ERRATA

Illinois Route 47 (Reed Road to U.S. Route 14) McHenry County, Illinois

Job No. P-91-101-07

August 10, 2016

MATCH LINE STA 423+00 IL 176

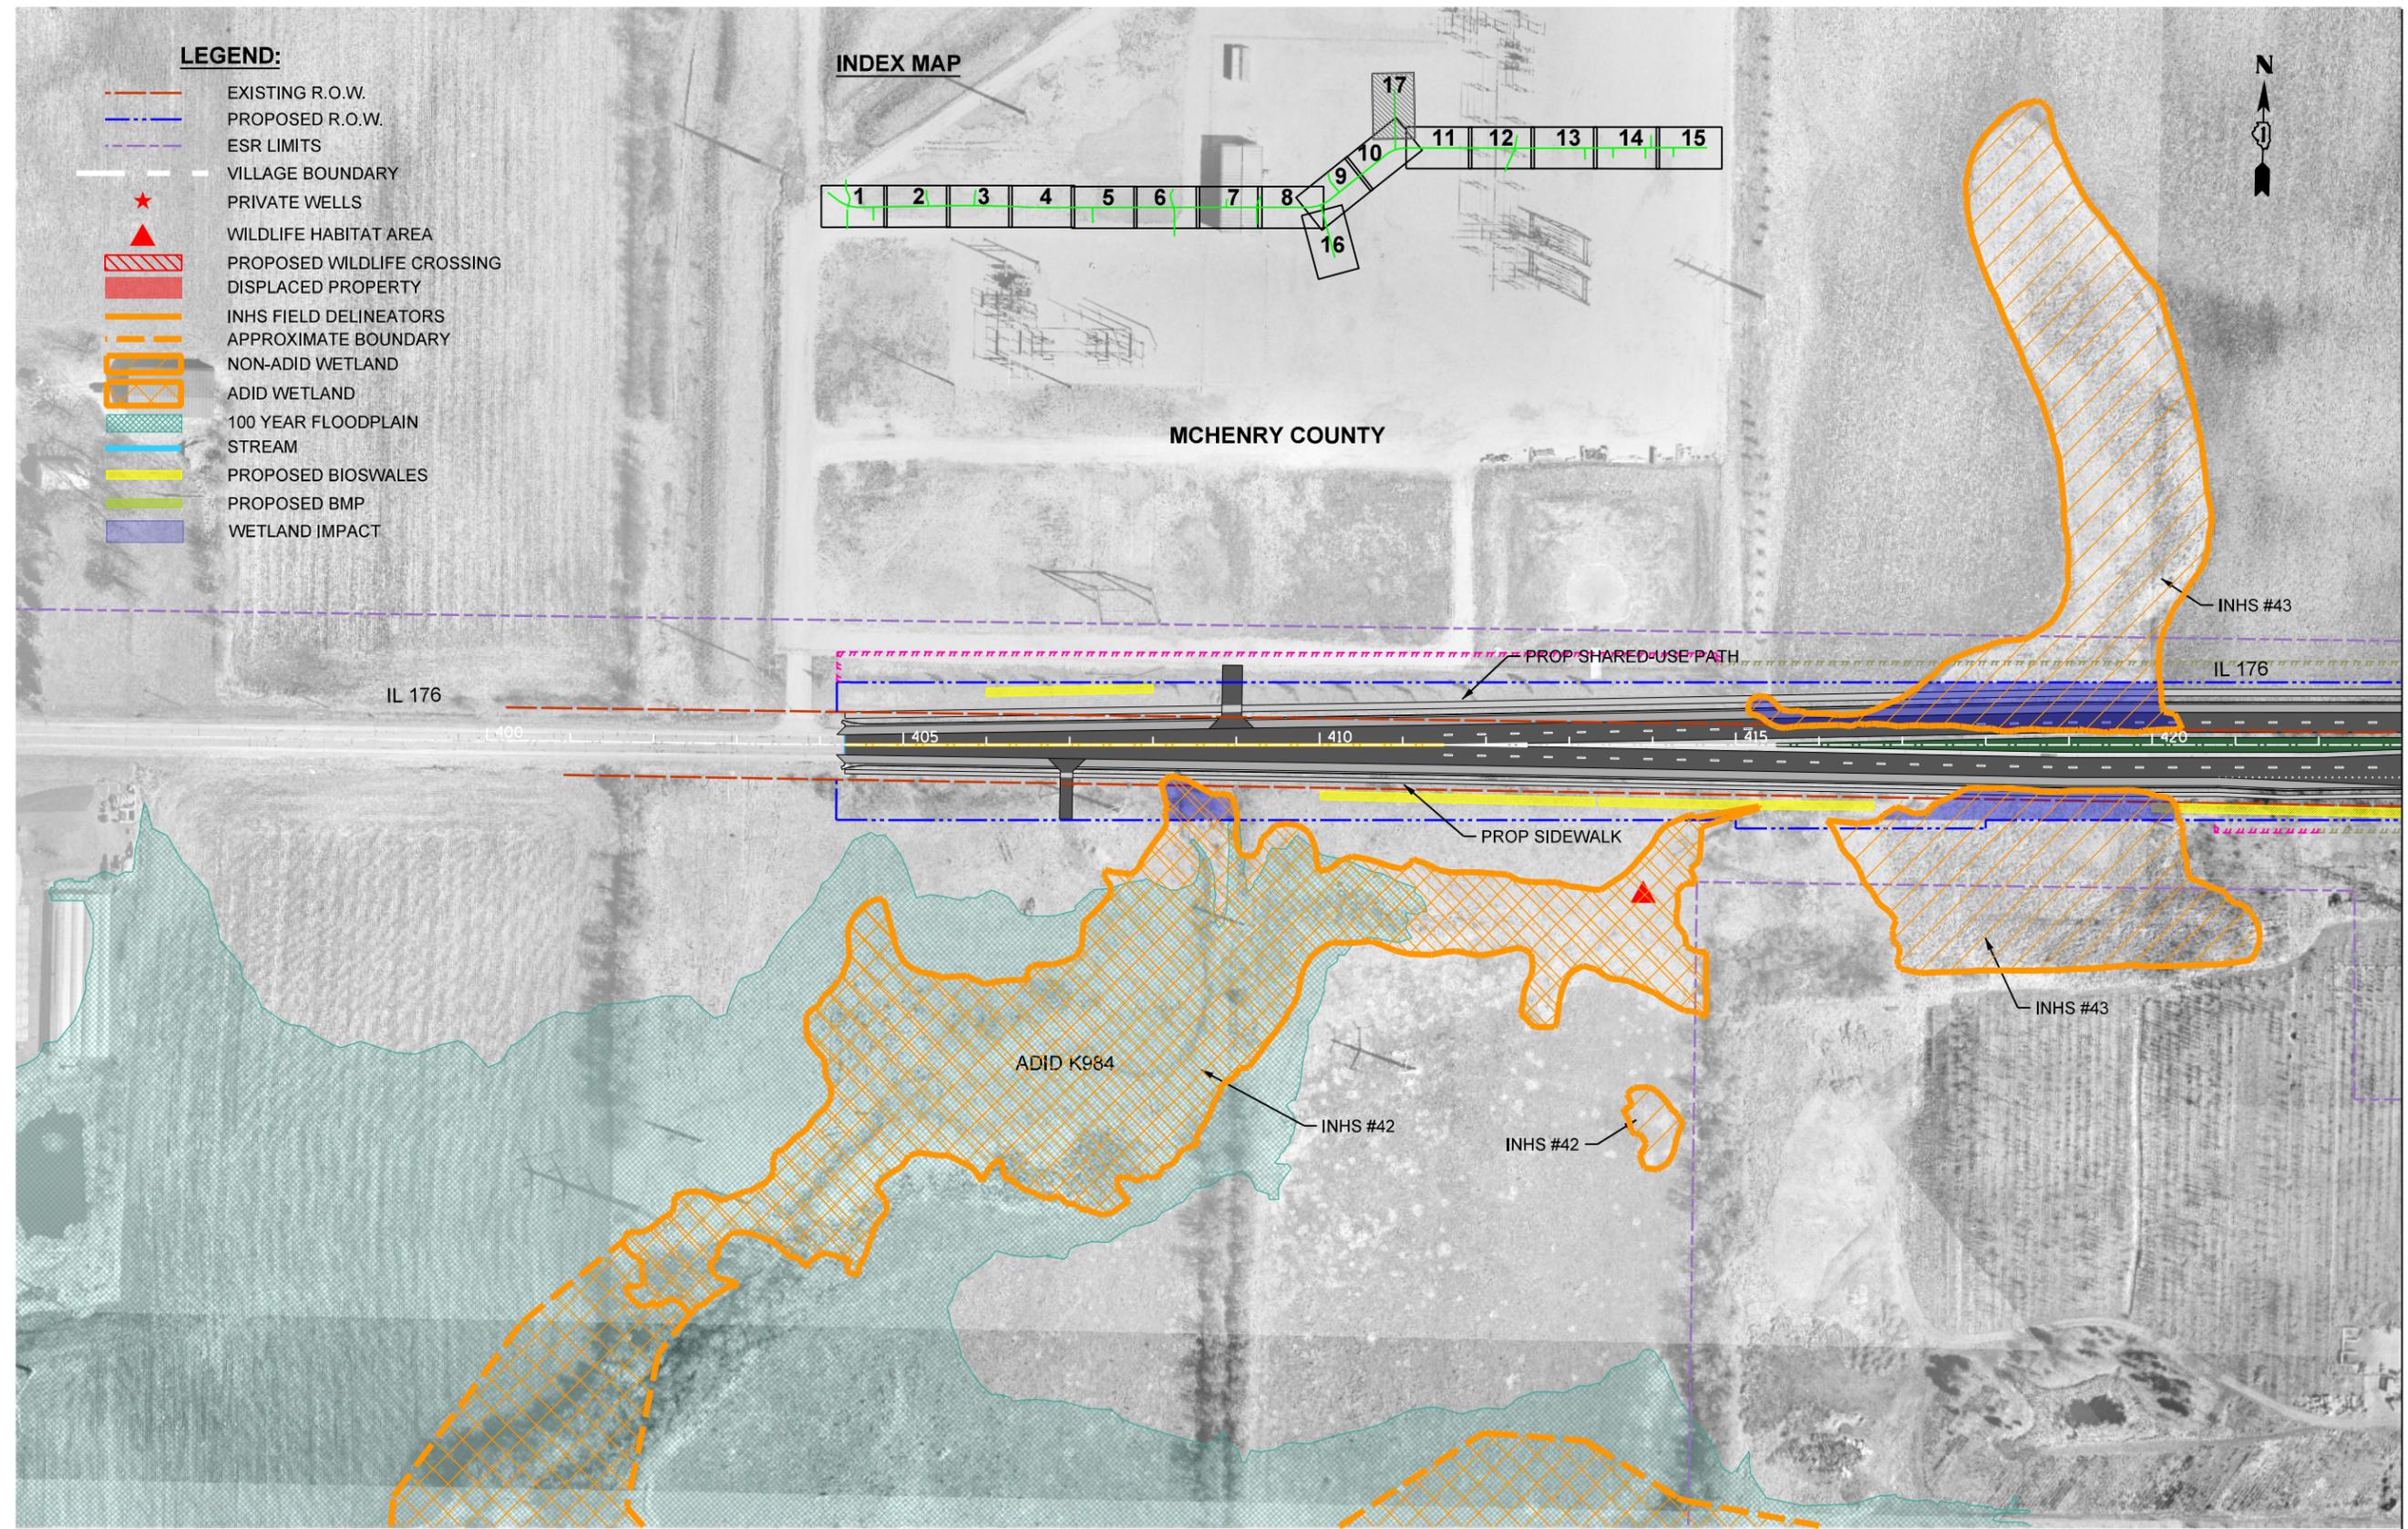
Replace Exhibit 4-1 Environmental Constraints Map to show updates to waterway names to be consistent with the Environmental Assessment, revised symbolization of the bioswales and inclusion of additional BMPs.

R	<p>A revised exhibit with a non-conflicting color scheme has been included in the Errata.</p>
87	U.S. Army Corps of Engineers	C	<p>The bioswale locations in Exhibit 4-1 should not be located within delineated wetlands or streams. Exhibit 4-1 should be revised accordingly for the final EA;</p>
		R	<p>The exhibit has been revised showing potential new locations as necessary. However, since the wetland impacts were considered to be everything within the ROW, those areas are proposed ditch locations where BMPs or bioswales are proposed; there may no longer be a functioning wetland due to construction disturbance. The design engineers will consider where regrading for the roadway and ditch work will take place while minimizing any impacts. However, there will be situations where the wetland will be graded out as part of the roadway and/or ditch construction, but these locations may be replaced with a bioswale.</p>
